## TECHNICAL SERVICE BULLETIN

### Shift Knob Rotates Without Brake Pedal Depressed, Transmission Remains In Park (P)

22-2343

Ford 2022 Bronco Sport	Built on 08-Nov-2021 and through 18-Jan-2022
2022 Escape	Built on 24-Sep-2021 and through 18-Jan-2022
2022 Maverick	Built on 13-Sep-2021 and through 18-Jan-2022
2021-2022 Mustang Mach-E	Built on 01-Aug-2021 and through 18-Jan-2022

Figure 1

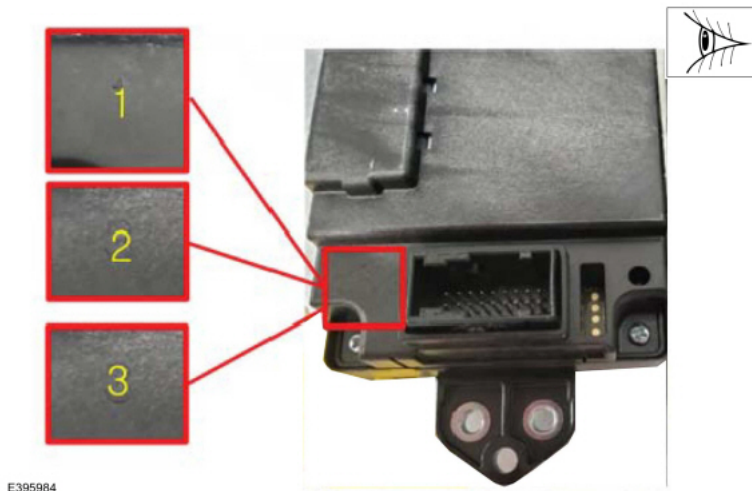
1. Remove center console trim. Refer to Workshop Manual (WSM) Section 307-05 Step 1.
2. Inspect the GSM at the location identified in Figure 1.

- (1). If the GSM is marked with numbers 1, 2, or 3, proceed to Step 4.
  - (2). If the GSM is marked with number 4 or blank, re-install GSM and proceed to Step 3.
3. Reprogram the GSM using the latest software level of the Ford Diagnostic and Repair System (FDRS). Repair is complete.
  4. Replace the GSM. Follow the WSM Section 307-05.
